**From:** Captain Dan Kipnis [captaindankipnis@att.net]  
**Sent:** Saturday, April 25, 2015 4:00 PM  
**To:** Williamson, Alicia; TurkeyPointCOLEIS Resource  
**Subject:** Turkey Point EIS comments and slide #1  
**Attachments:** Turkey Point 0-6 Ft Sea Level Rise.pptx

**Federal Register Notice:** 80FR12043  
**Comment Number:** 77

Sea Level Rise:  
6 Feet

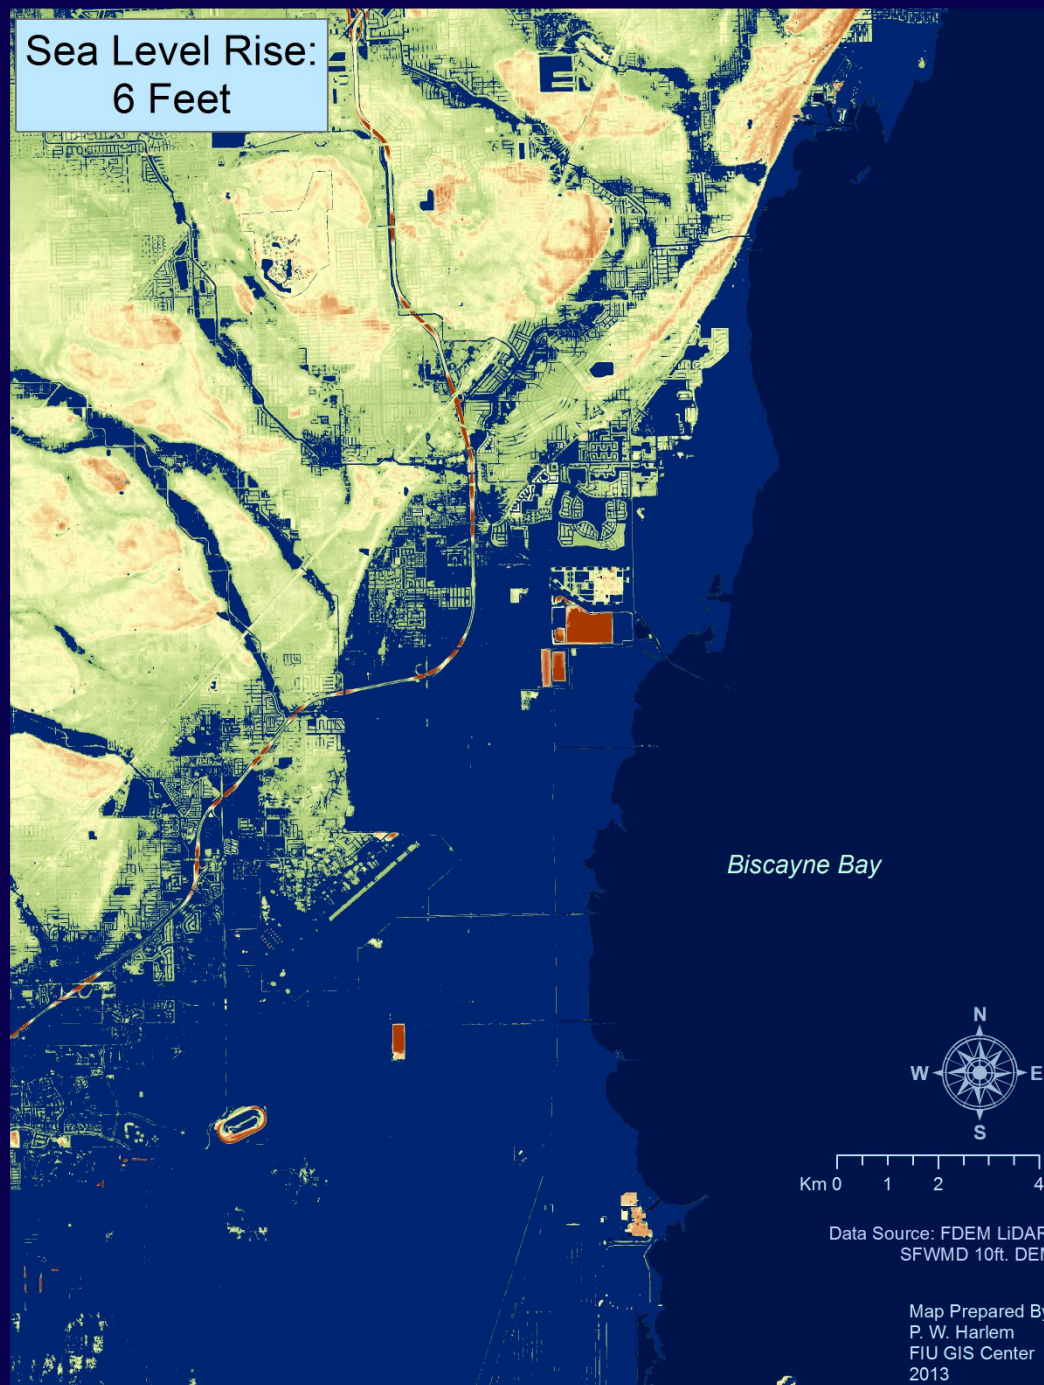
I would like to add these PowerPoint slides to the public record for your review of the Turkey Point EIS. They are closeups of the Turkey Point showing .5 - 6 feet of sea level rise and were prepared by Dr.

Peter Harlem of Florida Atlantic University. As you will see, sea level rise will have an immediate and ongoing effect on the plant site and it's surrounding environment. I tried sending them to [theturkeypoint.COLEIS@nrc.gov](mailto:theturkeypoint.COLEIS@nrc.gov) address and they were bounced back. They exceeded your mailbox limit.
